## Hilti PROFIS Engineering 3.0.88

### Area Area 1

## 20 ga 1.5B-36 Grade 50 Roof Deck

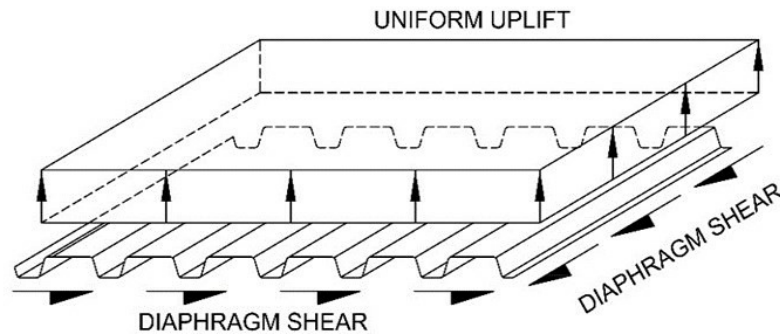
Shear design does not match Vulcraft's calc, why is there a difference?

## 20 ga 1.5B-36 Grade 50 Roof Deck

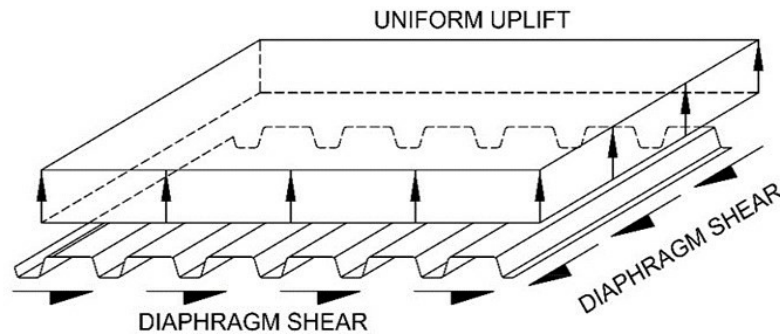
Shear design does not match Vulcraft's calc, why is there a difference?
